MIL-C-70996 (AR)
AMENDMENT 2
22 July 1996
SUPERSEDING
AMENDMENT 1
19 May 1994

CARTRIDGE, HE, 81MM, M821E1/M889E1 W/FUZE M734/M935
LOADING, ASSEMBLING AND PACKING

This amendment forms a part of MIL-C-70996(AR), dated 9 May 1991, and is approved for use by the U.S. Army Armament Research, Development and Engineering Center, and is available for use by all Departments and Agencies of the Department of Defense.

FIGURE 1. SEGMENTAL DEFINITION

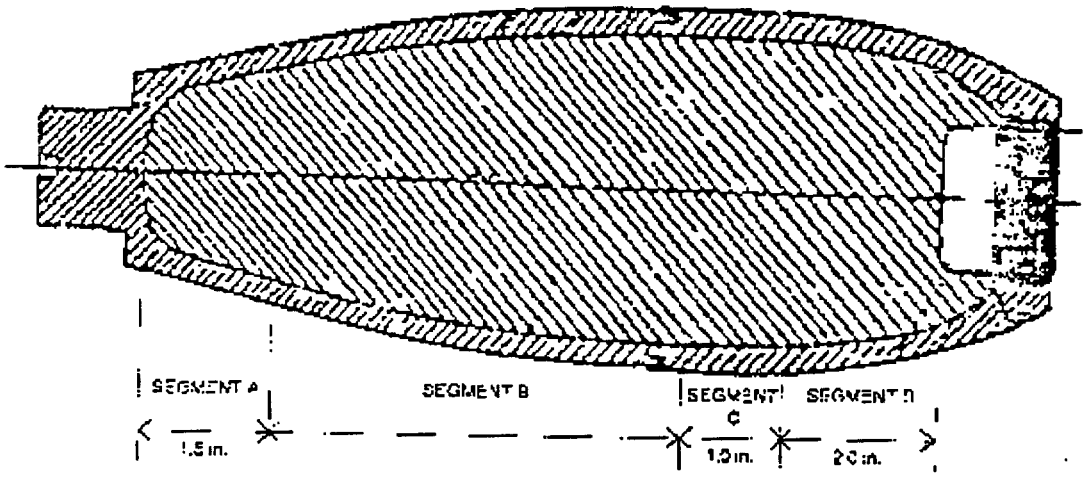
* Table III: Delete in its entirety and substitute:

SEGMENTS (see Figure 1)			
Sum of projected area of the cavities, excluding pipes, cracks and annular rings, square inch	1/16	1/4	1/2	1/2
Projected length of any cavity excluding pipes, cracks and annular rings, inch	1/4	1/2	1/2	3/4
Piping cavities, maximum projected area, square inch	0	1/4	1/2	NA
Piping cavities, maximum projected width, inch	0	1/2	1/2	NA
Cracks, maximum projected width, inch	1/20	1/20	1/20	NA
Annular rings, maximum projected width, inch	0	0	1/4	NA"

"TABLE III. Cavitation requirements.
